MODIFICATION

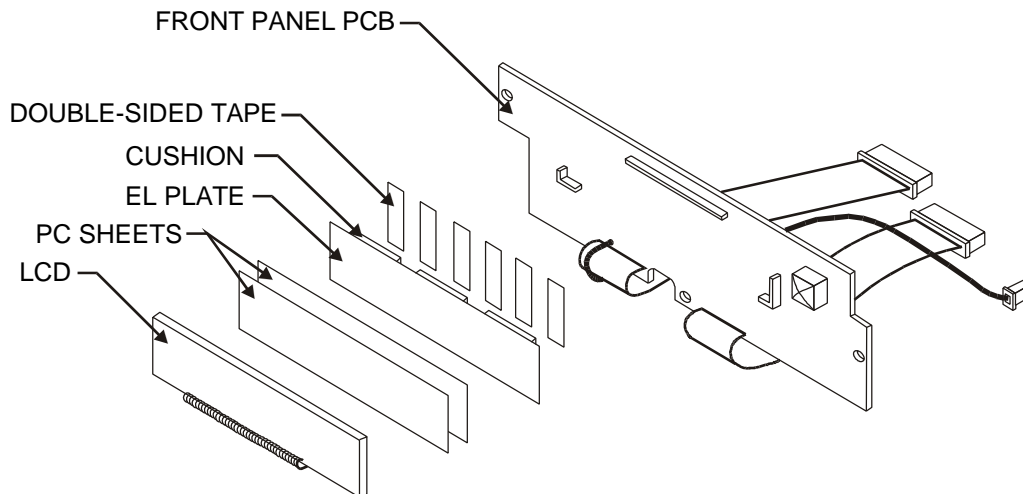
You may receive a complaint of the unit producing a very high whistle noise

The step up transformer for the display circuit is humming

1. Insert a transformer with more varnish impregnation
2. Apply glue to fix the step-up transformer to the main pcb
3. Add double sided tape between the cushion at the back of the EL display and the front panel pcb. Please refer to the drawing below
